ADDENDUM NO. 2
to
CONTRACT DOCUMENTS

for
ADDITIONS AND RENOVATIONS
to the
COMMUNITY PARK ELEMENTARY SCHOOL
located at 372 Witherspoon St, Princeton, NJ 08542

for
PRINCETON PUBLIC SCHOOLS
PRINCETON, MERCER COUNTY, NEW JERSEY

Issued: January 23, 2026

Drawing Number
A702

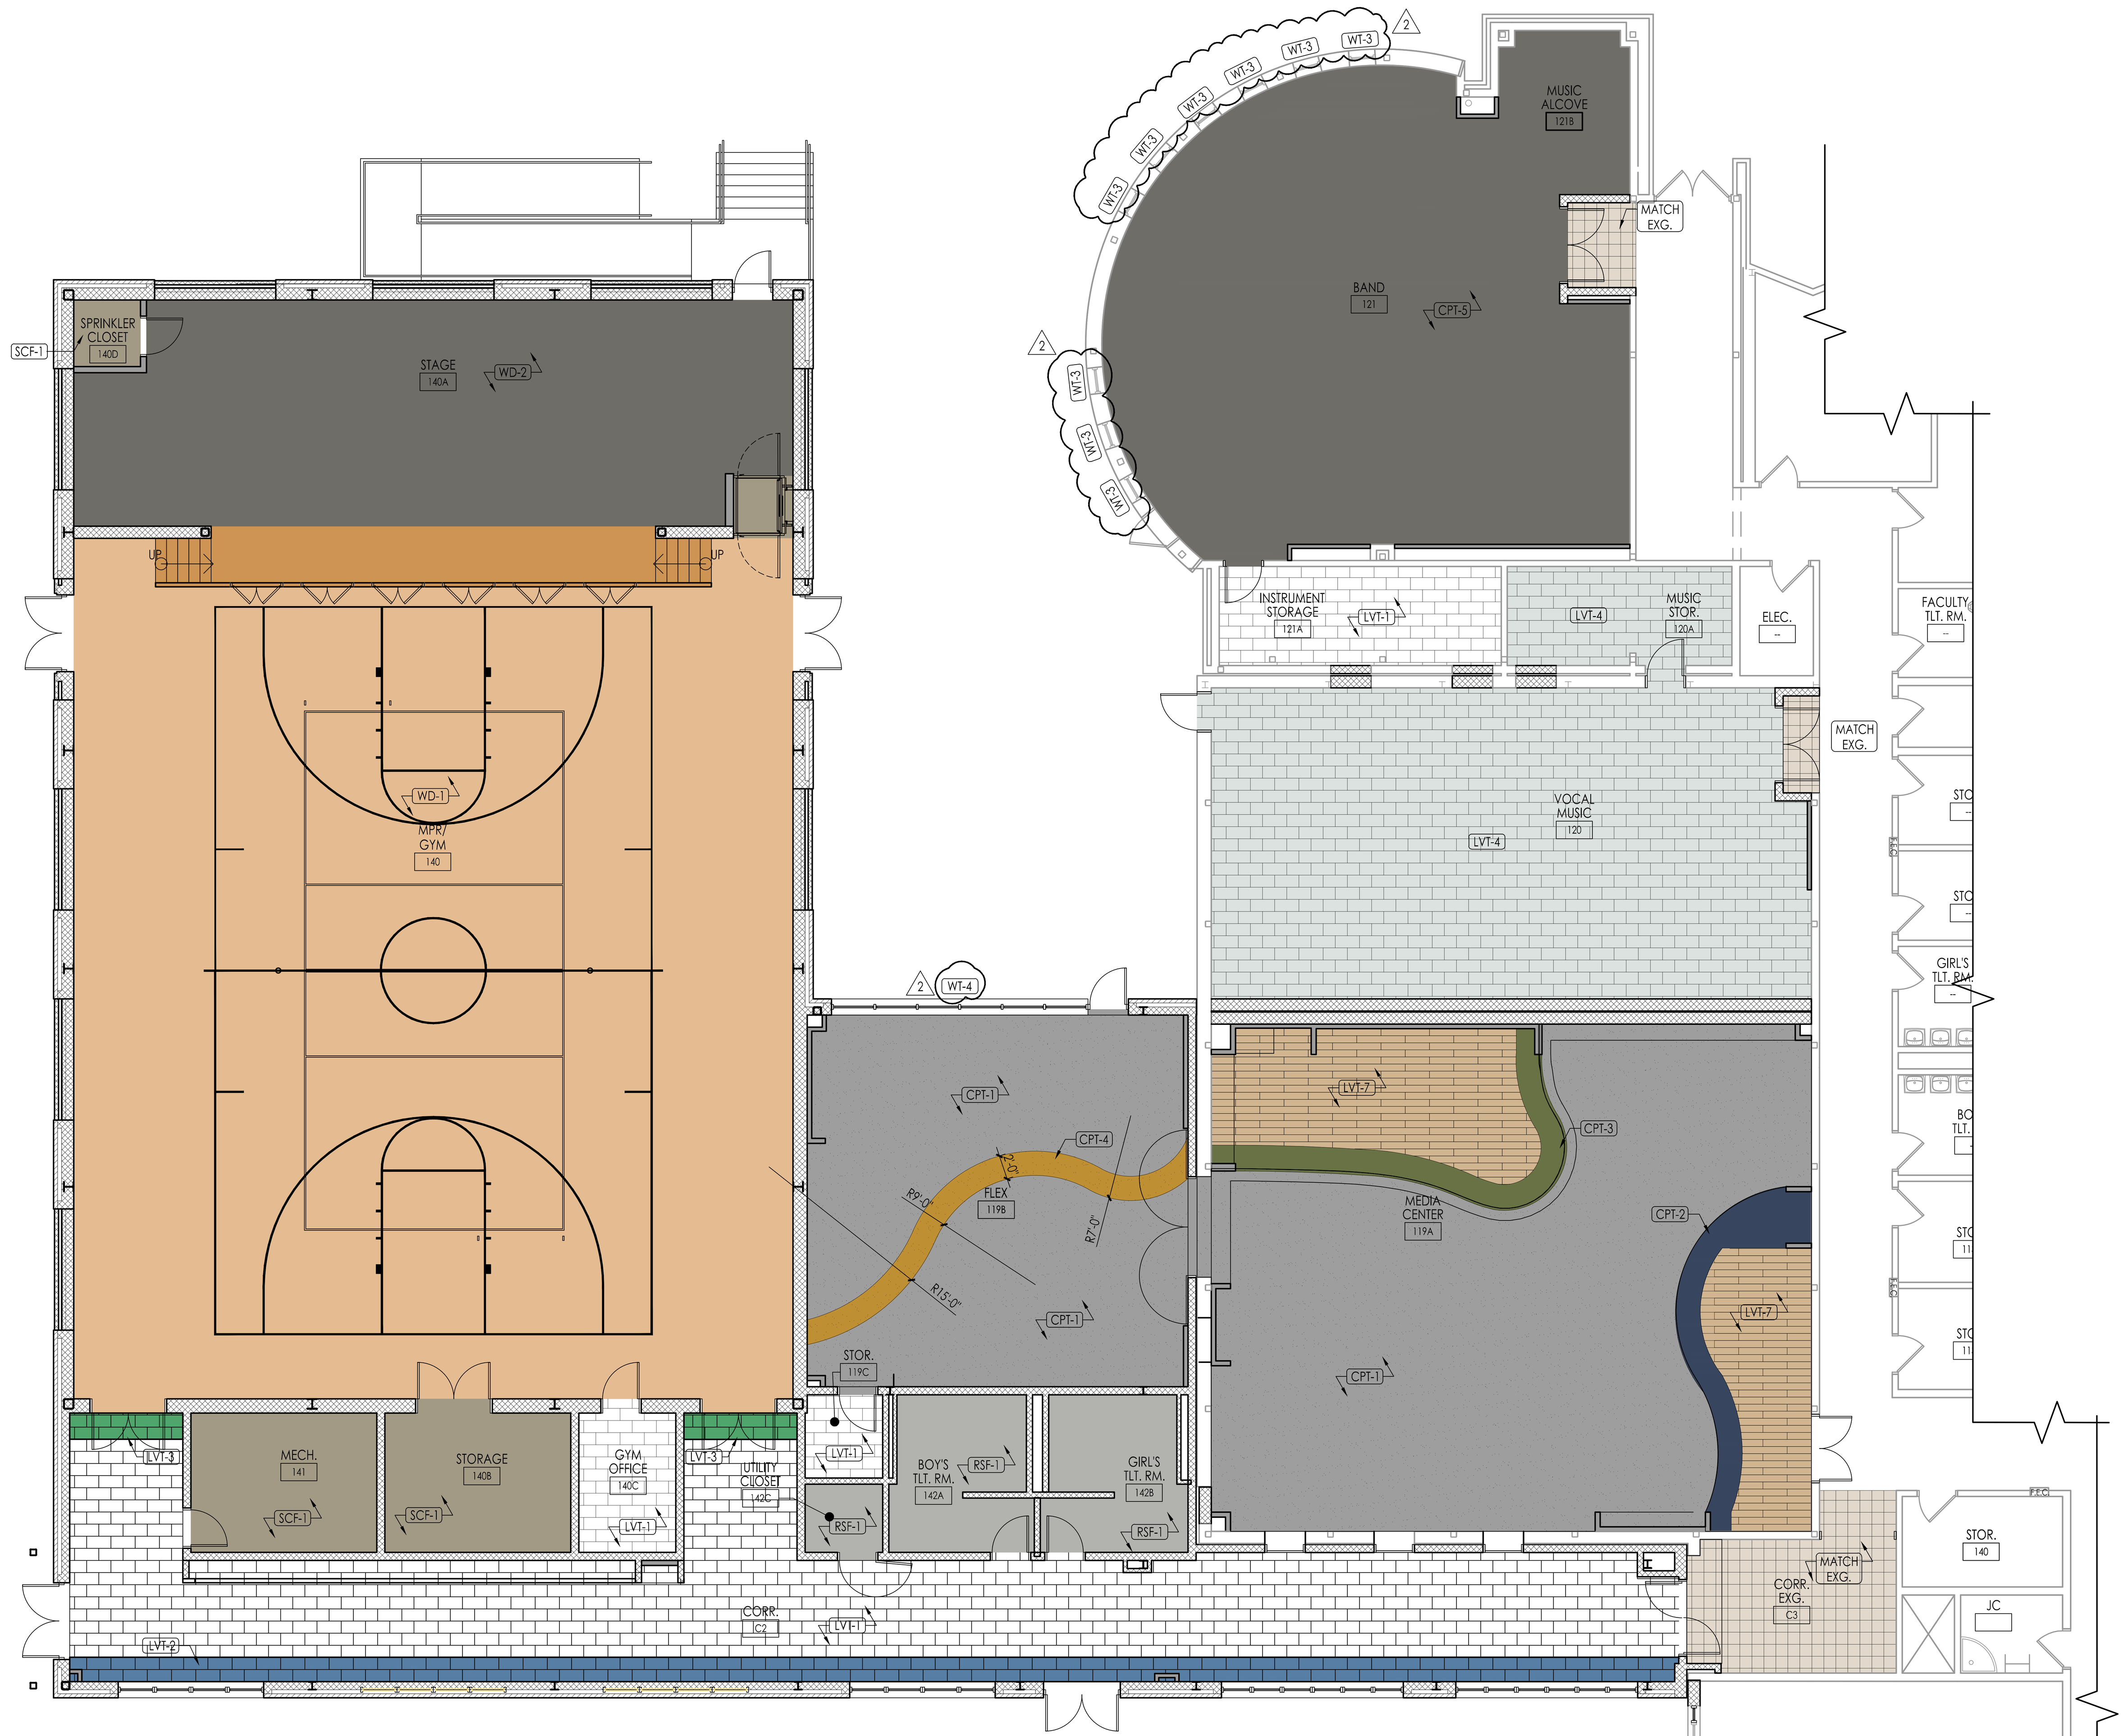
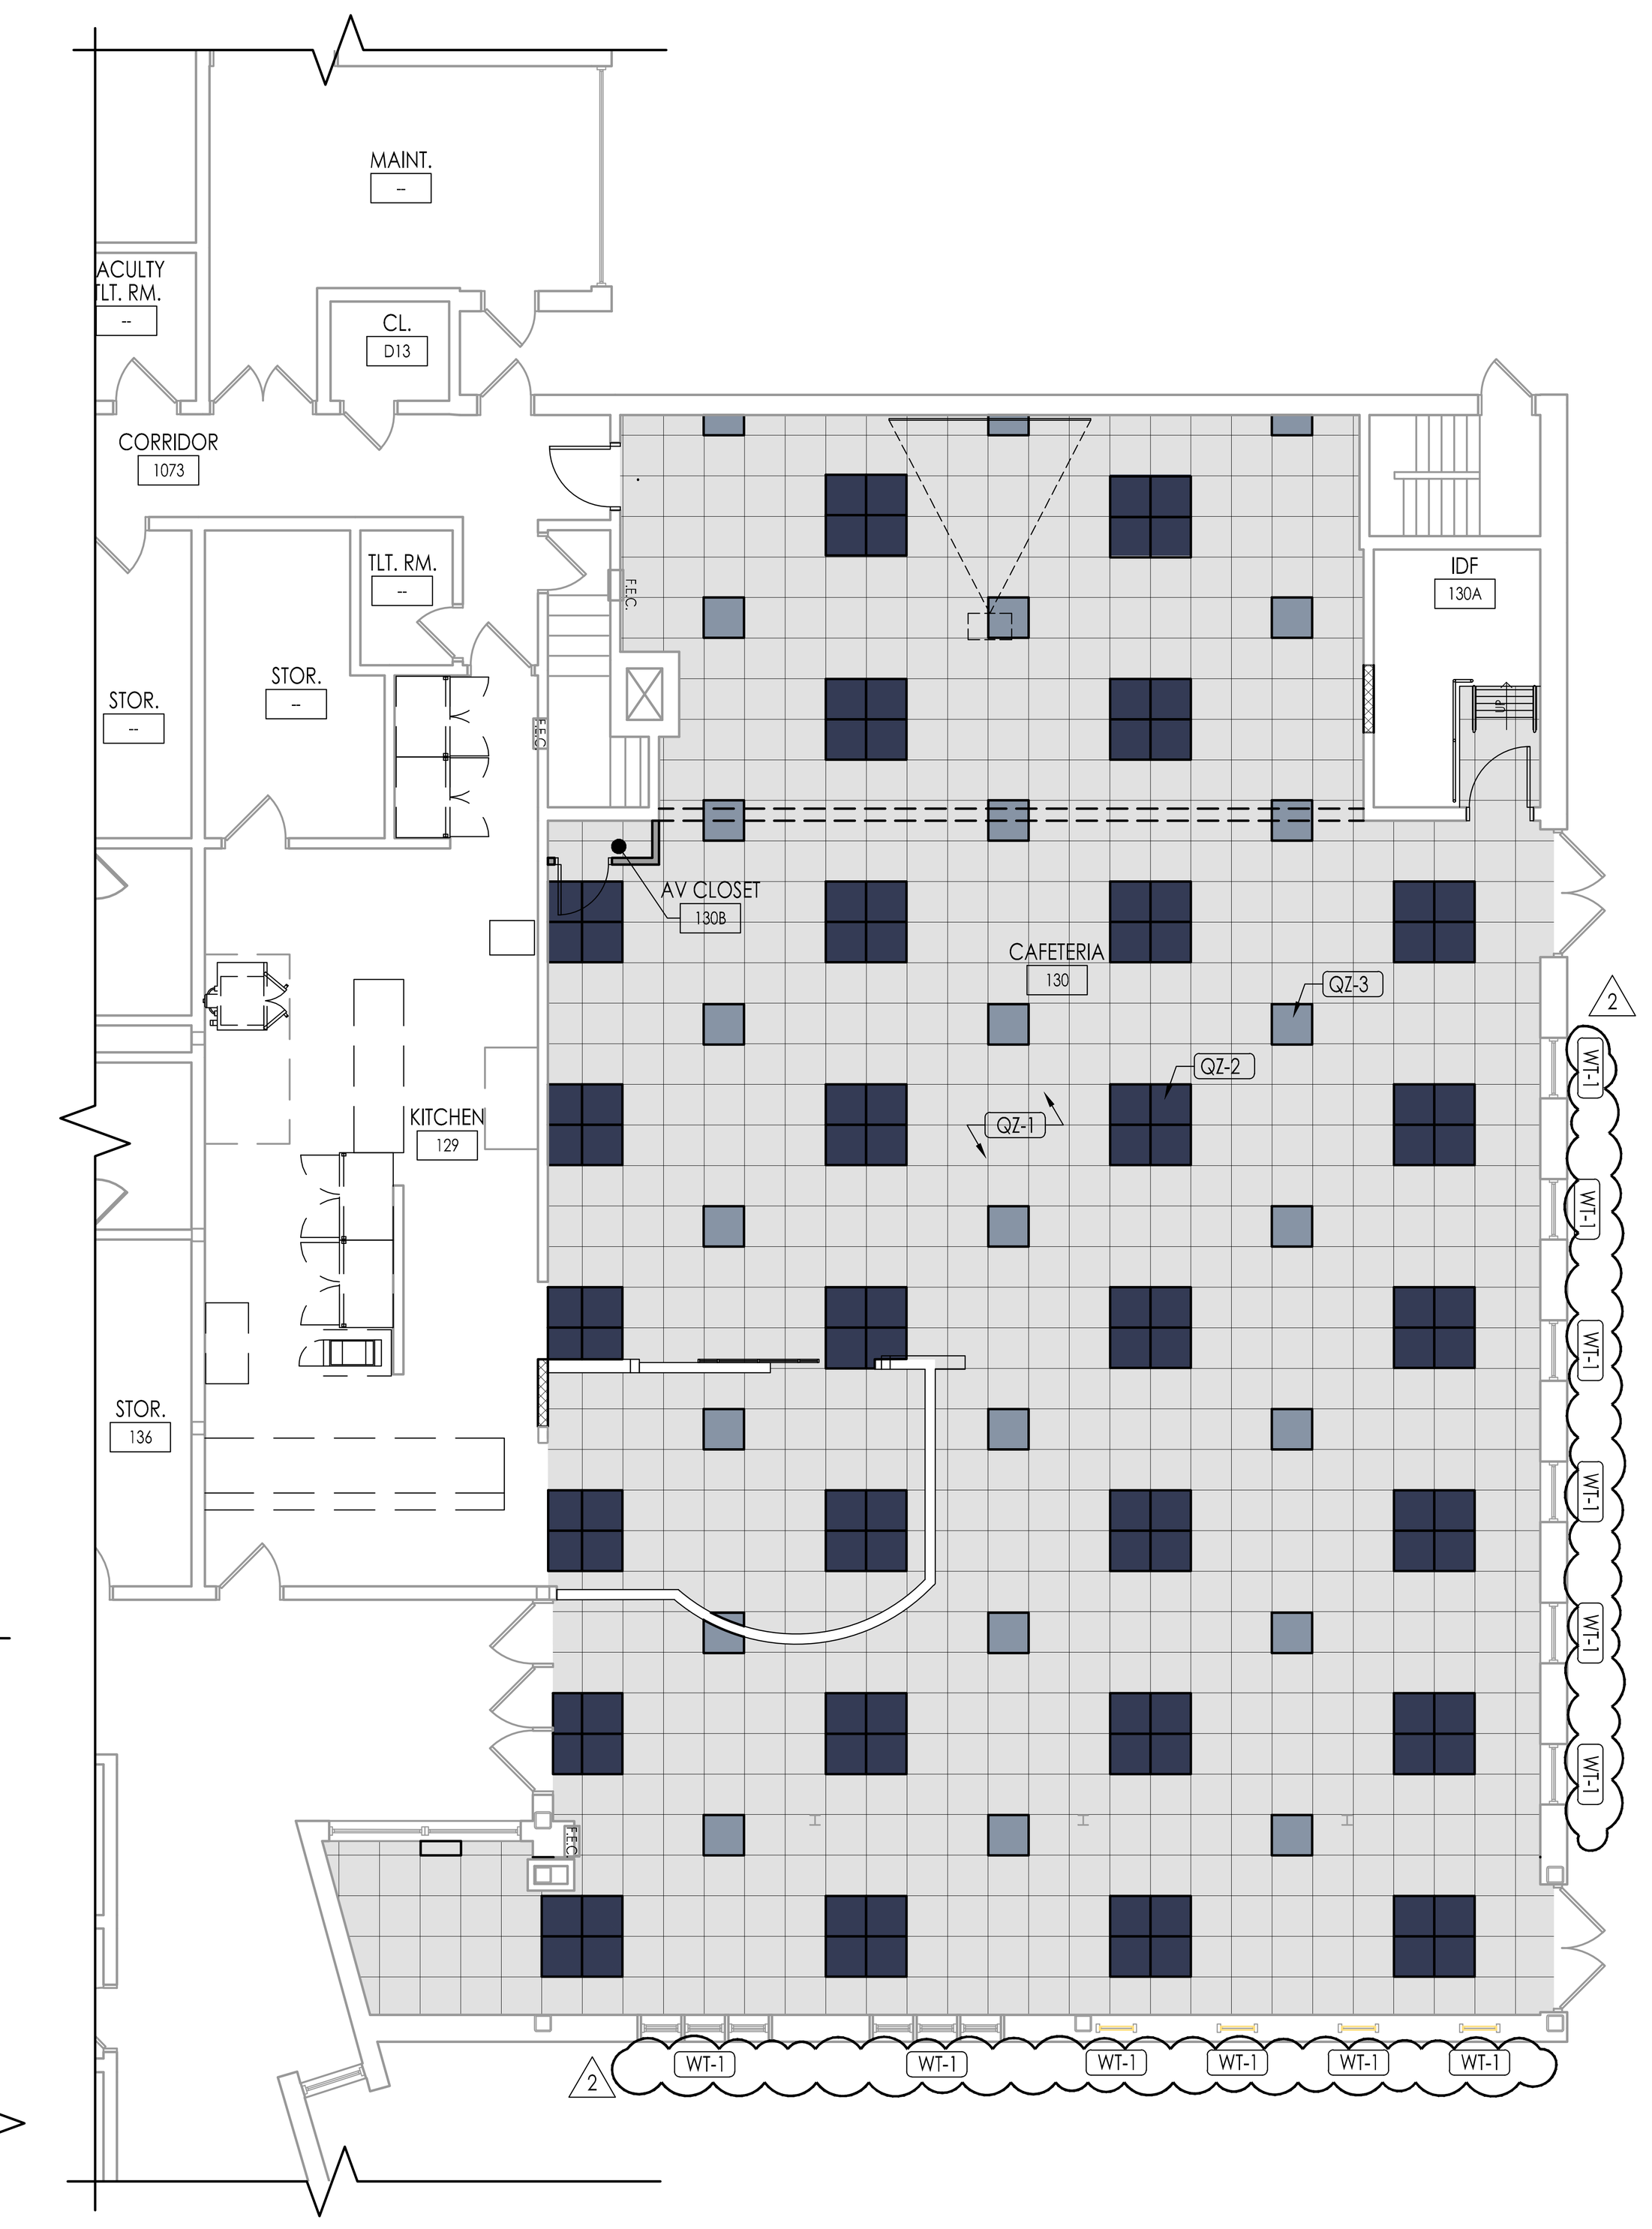
16. Question: On A-702 window treatment callouts are not very visible in dark areas on printed drawings, please move designation to a more visible area and reissue this drawing.

Response: See revised drawings A702 and A703, attached to this Addendum.
